# Responses to Comments on Draft Environmental Impact Report

## For the San Francisco Public Utilities Commission's Regional Groundwater Storage and Recovery Project

July 9, 2014

Case No. 2008.1396E

**Figure 3-2 REVISED**

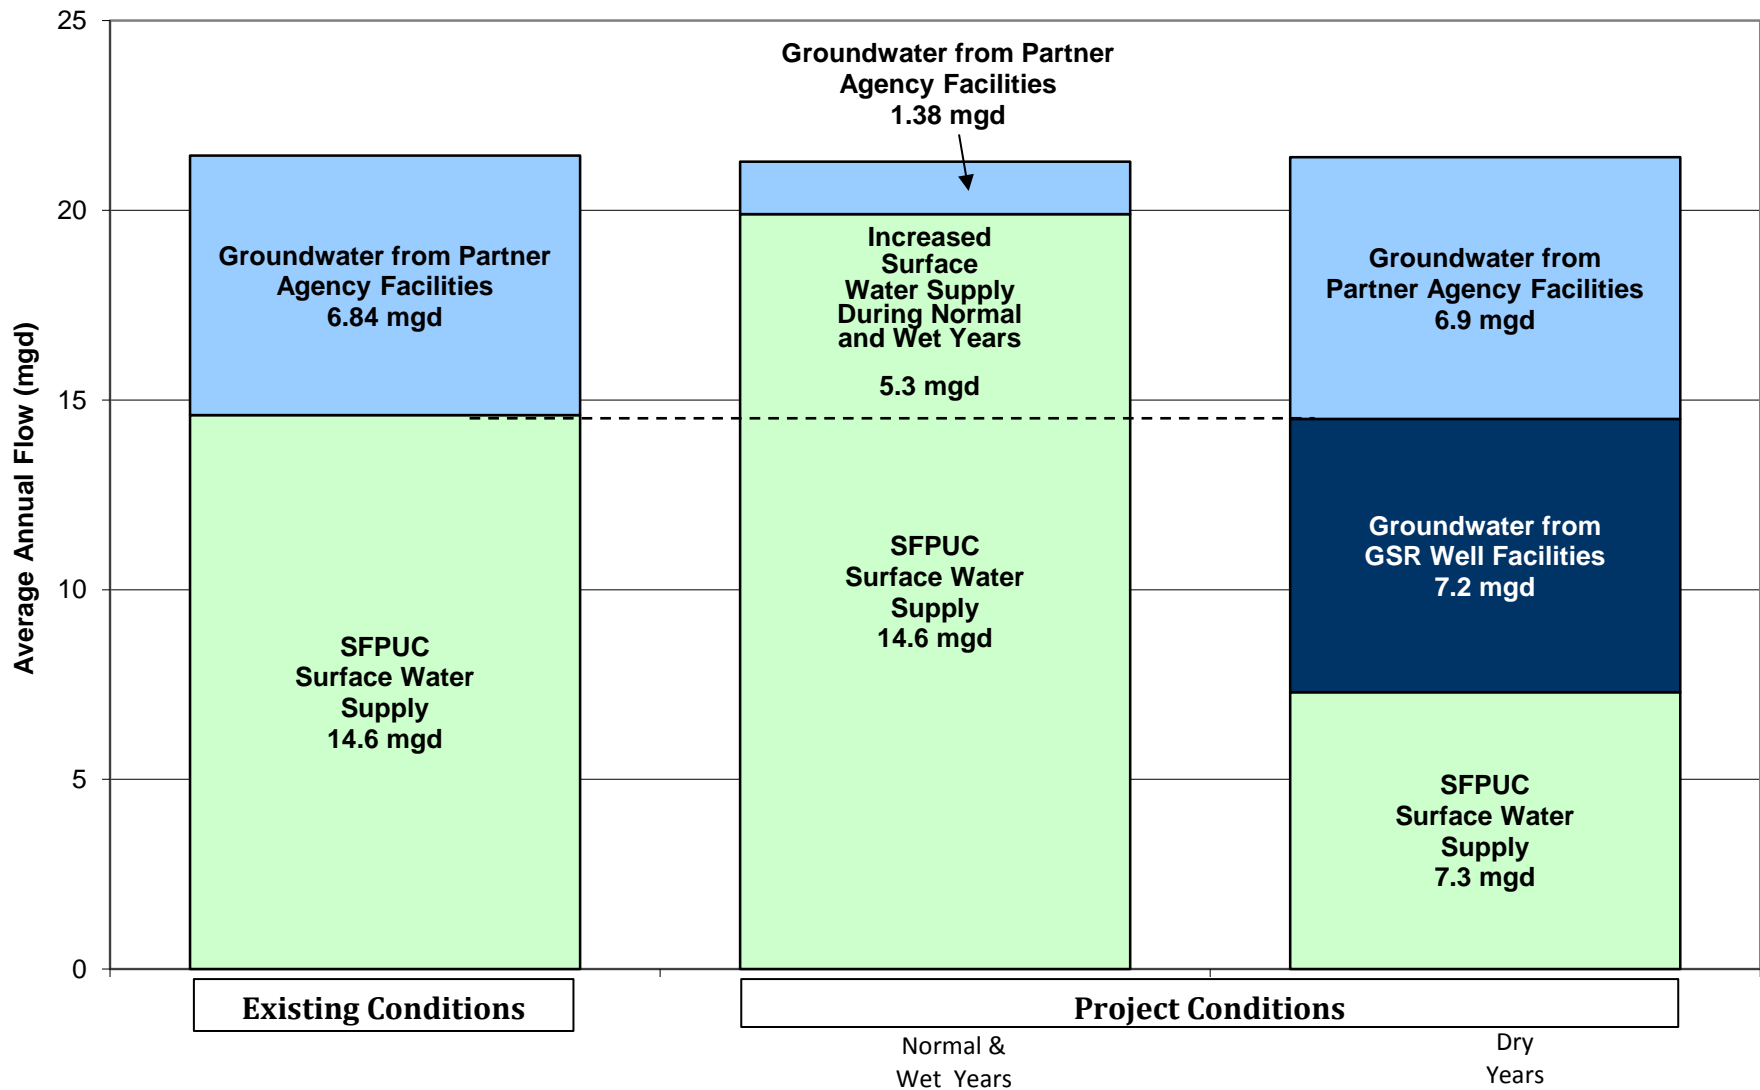
“8. Section 3.4.1 – Groundwater Storage and Recovery, Figure 3-2 (page 3-9). The volume of surface water deliveries should be added to the Project Conditions portion of Figure 3-2. Also, for Figure 3-2, please clarify, what year the demand is representative of (i.e. is it current conditions or 2035 conditions).”  
(BAWSCA, letter, May 24, 2013 [G-BAWSCA-Sandkulla])

The comment requests changes to figures in Chapter 3, Project Description. Regarding Figure 3-2 (Source of Proposed Water Supply for Partner Agencies) in Chapter 3, Project Description of the Draft EIR, the figure shows sources of supply, not demand. The figure shows surface water supplies for both existing and Project conditions (please refer to the labels on the lower axis of the figure). To further clarify the sources of supply during normal and wet years under the Project, the green portion of the center bar is revised on the graph to show 14.6 mgd of the SFPUC surface water supply, which corresponds to the amount currently available under existing conditions, and 5.3 mgd of “increased surface water supply during normal and wet years” in the area above the dotted line on the bar chart. This represents the additional surface water that would be supplied to Partner Agencies to allow a reduction in pumping, thereby providing in-lieu recharge. Please refer to Revised Figure 3-2, which follows this page.

*Description of Revision:* Figures 3-2 (Source of Proposed Water Supply for Partner Agencies) and 3-37 (Site 16, Millbrae Corporation Yard) have been revised and are included in Section 9.3.3, Project Description, of this Responses to Comments. Figure 3-2 has been revised in response to Comment PD-3, which requested that the volume of surface water deliveries be added to the Project Conditions portion of the figure, so as to clarify the sources of supply during normal and wet years. Figure 3-37 has been revised in response to Comment PD-3 to correct the identification of labeling of an existing building near Site 16; the label has been revised from convalescent hospital to multi-family residential.

Figure 3-23 REVISED

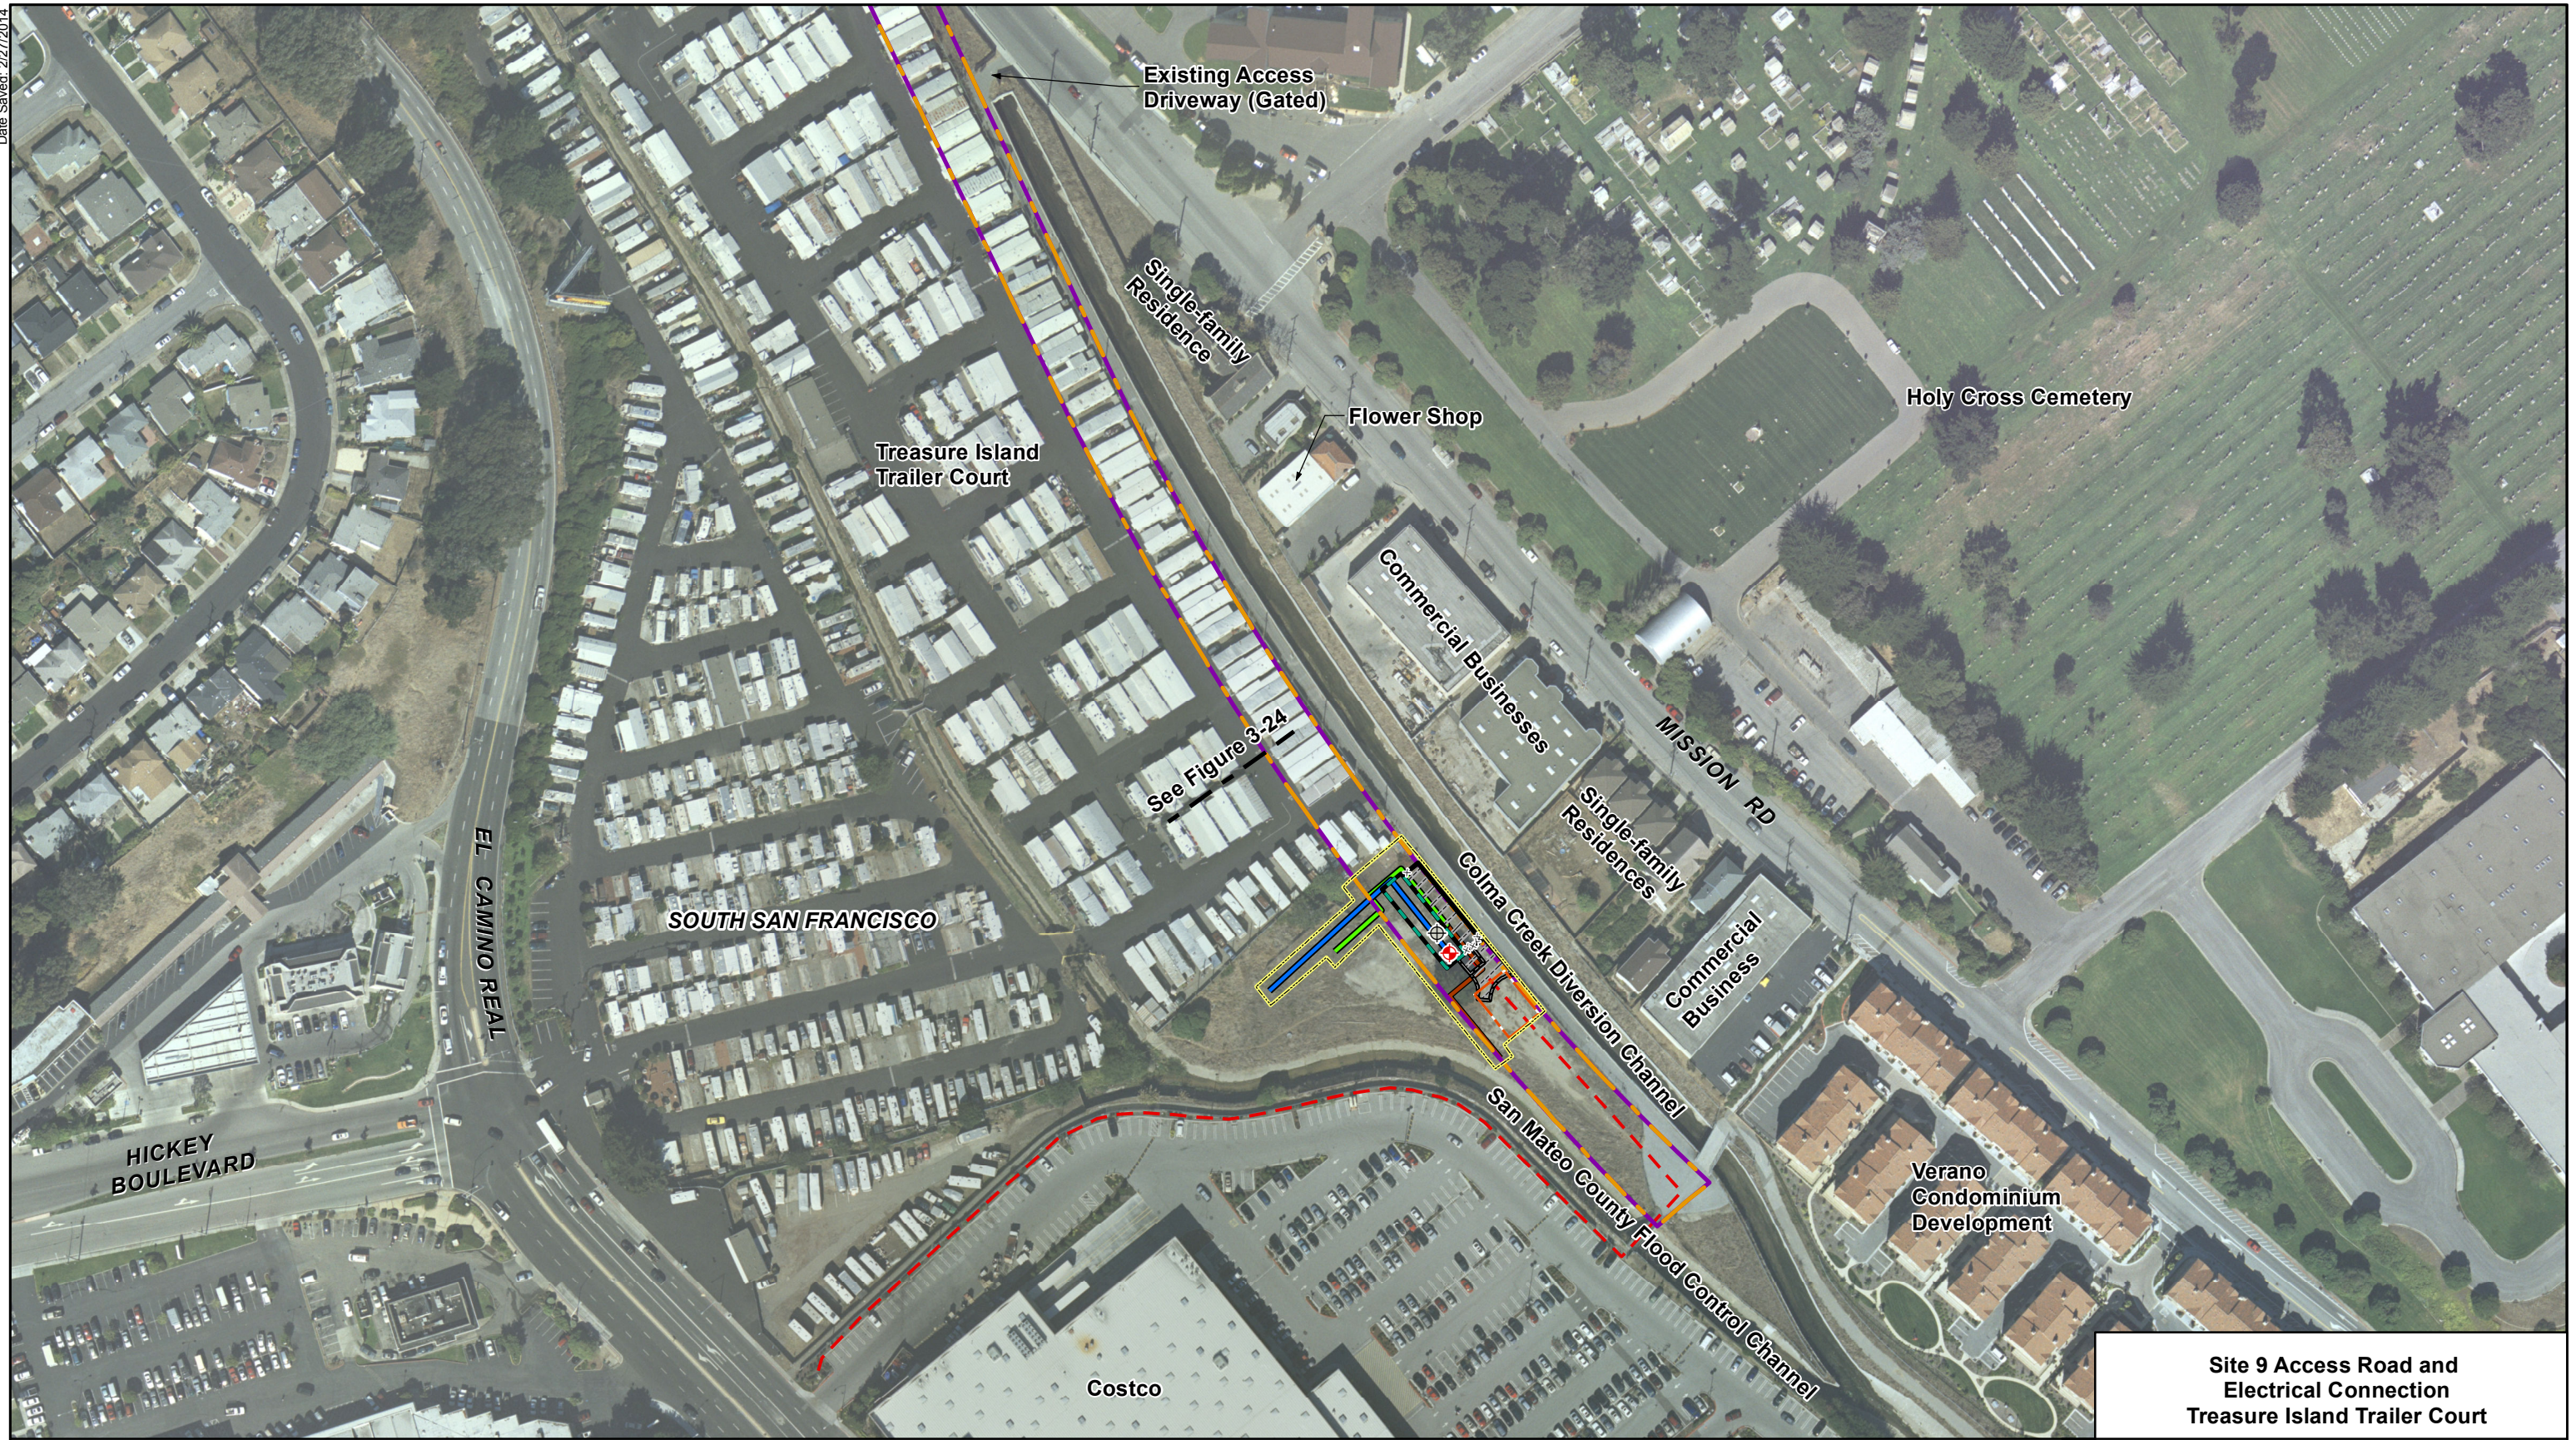
“*Site 9 Overhead Electrical Connection.* Figure 3-4 shows that Site 9 requires an electrical connection through a commercial business in the Town of Colma. This electrical connection is proposed to be above ground, which is unacceptable. The line would impact the existing commercial business and visually impacts views from the Verano neighborhood. The Town of Colma requires undergrounding of utilities for all new construction, from the pole to the project site pursuant to Municipal Code Section 5.09. In addition, General Plan policy 5.02.361 requires that all new construction projects to place utilities

*"Site 9 Visual Impacts.* Figure 3-23 shows that a chemical treatment and filtration building will be highly visible from the back windows of 4-5 historic residences to the east within Colma, in addition to residences at the Verano neighborhood. The Final EIR must address this visual impact and mitigation."  
(*Colma Planning Department, letter, May 28, 2013 [G-Colma-Laughlin]*)

Draft EIR Figures 3-23 (Site 9, Access Road, Treasure Island Trailer Court), 3-24 (Site 9, Treasure Island Trailer Court) and 5.14-7 (Site 9, Treasure Island Trailer Court, Jurisdictional Waters) have also been revised to reflect this change.

Draft EIR Figures 3-23 (Site 9, Access Road, Treasure Island Trailer Court) and 3-24 (Site 9, Treasure Island Trailer Court) have also been updated to reflect the revised site plan; the revised figures are presented in Section 9.3.3, Project Description, of this Responses to Comments.

In response to Comment PD-5, Figure 3-23 (Site 9 Access Road Treasure Island Trailer Court) (page 3-77) and Figure 3-24 (Treasure Island Trailer Court) (page 3-78) are revised to reflect the buried electrical line to Site 9. The revised figures are presented in Section 9.3.3, Project Description, of this Responses to Comments document.
